8 March 2024
Job No: 1017346.3000

Weld Road Pathway and Ahu Ahu Bridge Taranaki Regional Council Section 92 response (23-11174-1.0)

This letter provides a response to the section 92 further information request (ref: 23-11174-1.0) received from Taranaki Regional Council (TRC) dated 12 December 2023. Numbering and questions from TRC are in italics as per the section 92 further information request, with Tonkin & Taylor Ltd's (T+T) response below each question.

CLIENT	NEW PLYMOUTH DISTRICT COUNCIL		
PROJECT	WELD ROAD COASTAL WALKWAY		
TITLE	WALKWAY CROSS SECTIONS SHEET 1		
SCALE (A3)	1:200	DWG No.	1017346.3000-41
REV	A

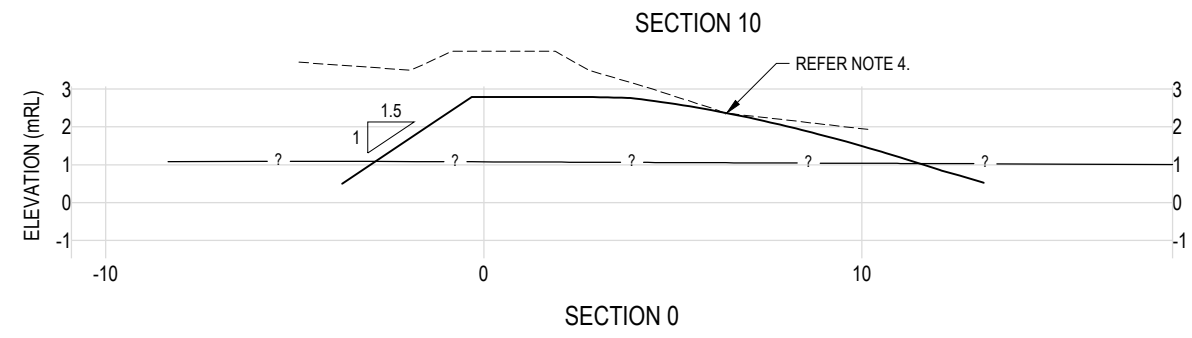
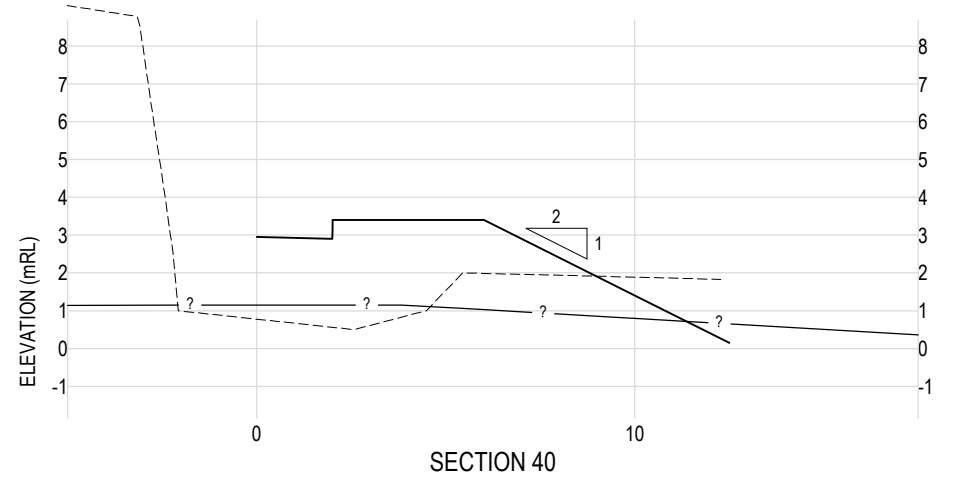
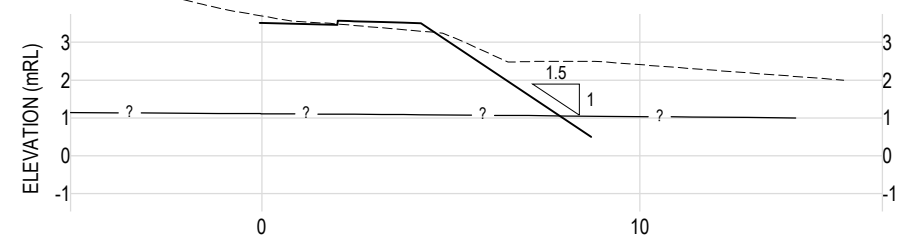
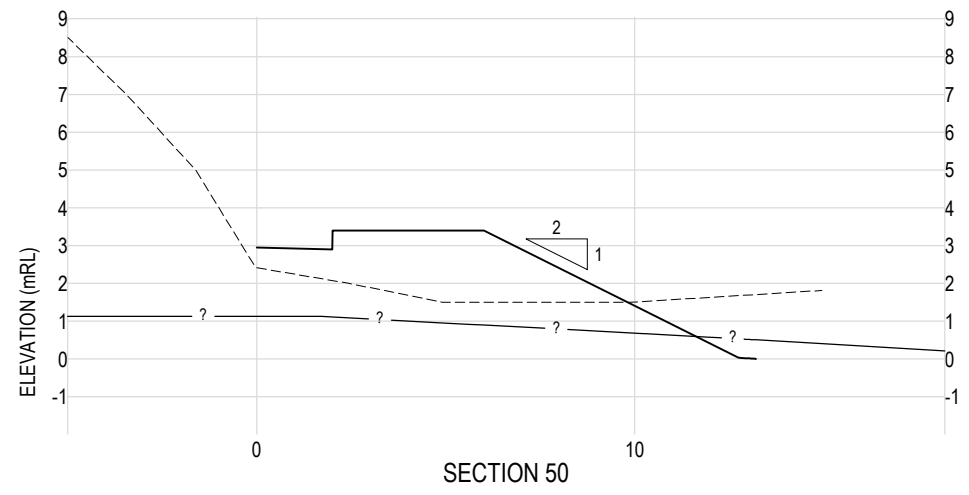
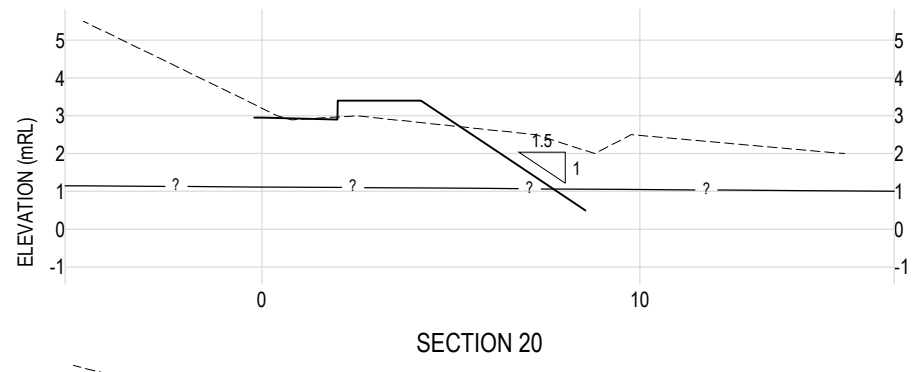
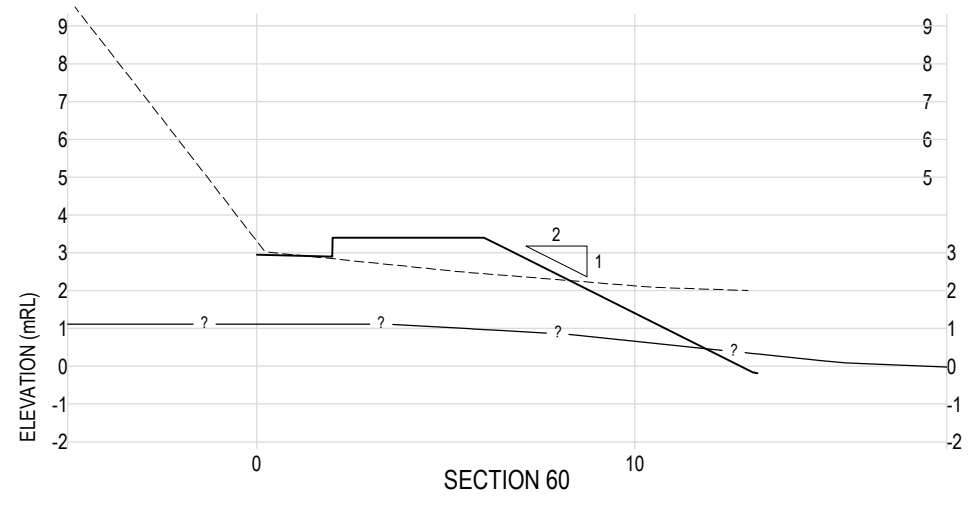
- 4 *The application states that flood level modelling assumed that rock revetment would be placed on both sides of the stream, however as rock revetment is now proposed for only the west side of the stream, the flood levels will be lower and the freeboard achieved will be greater. Therefore, please confirm what the difference in flood level/freeboard is.*

- 5 *A risk assessment of flow erosion outflanking the structure on the area in the true left abutment where the extent is limited by the property boundary. The Council's Rivers Engineer notes that the stream alignment will likely promote erosion in this area.*
- 6 *Further to the above, please provide details of the natural vegetation and root structure support in this area.*

Response [5 & 6]: As advised in an email issued by Peter Quilter (Senior Coastal Engineer at Tonkin + Taylor Ltd) to Chris Vicars (River Manager at TRC) on 21 February 2024, "Exposures in material that form the headland generally demonstrate scour resistance. It will be necessary to terminate the end of the rock revetment into this material to avoid the possibility of outflanking (scour around the ends of the structure that could compromise its stability). It will be necessary to include a note on construction drawings with words to this effect."

In addition, an inspection can be carried out by a suitably qualified engineer (civil/coastal/geotechnical) who can confirm on-site the adequacy of founding materials (particularly if there is a weathering sequence) during excavation. This could form a requirement of the consent conditions together with detailed design plans for approval. On the basis of the above, we consider the risk of erosion outflanking the structure can be appropriately addressed through the design of the structure.

- NOTES:**
1. ALL DIMENSIONS IN METRES UNLESS NOTED OTHERWISE.
 2. EXISTING GROUND SURFACE PROVIDED BY WSP (RECEIVED 27/03/2023).
 3. HEIGHTS ARE IN TERMS OF NZVD2016.
 4. FINISHED SURFACE SLOPE 1V : 2H TRANSITIONED TO 1V : 1.5H NEAR STREAM, AND CREST WIDTH REDUCED FROM 4.0m TO 2.2m, REFER TO DRAWING 1017346.3000-10.
